DOCUMENT 00 91 01

**ADDENDUM NO. 2**

Dated May 20, 2024

**R** COVERED WALK  
S3 1" = 1'-0"

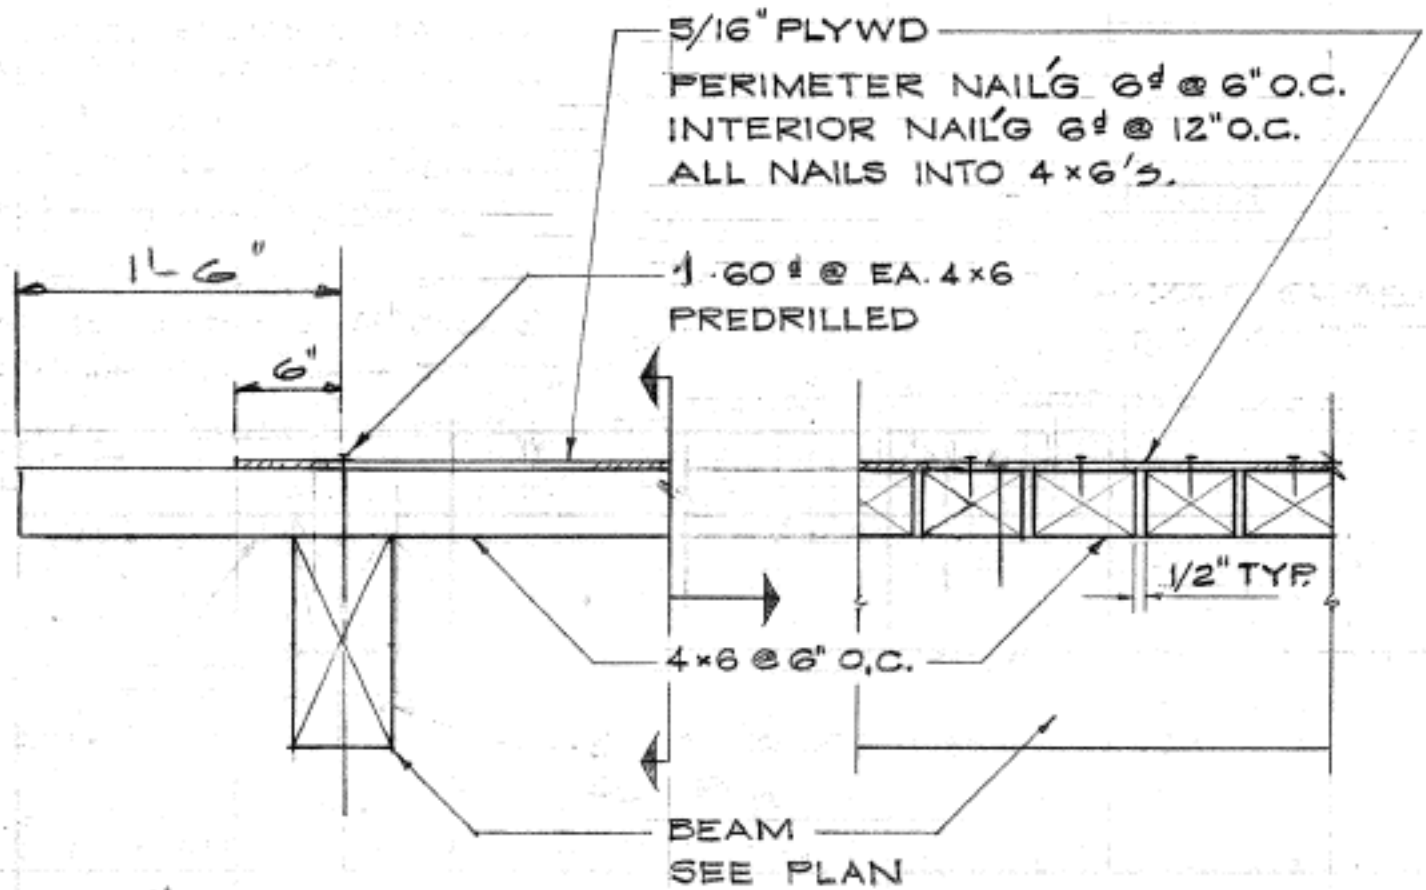
2. The contract docs do not define roofing or decking requirements. It can be observed the roof assembly included 2x6 T&G. Is there a layer of plywood above the 2x6 that needs to be patched? Is it probable that a layer of plywood is over the 2x6 (it would be a bad practice to have roofing directly over the 2x6 T&G) and is the substrate for the roofing underlayment. Can as-builts be provided with detail of the assembly? What plywood patch is needed and what ply thickness is the existing assembly composed of?

**Answer: See Asbuilt Detail No. 02**
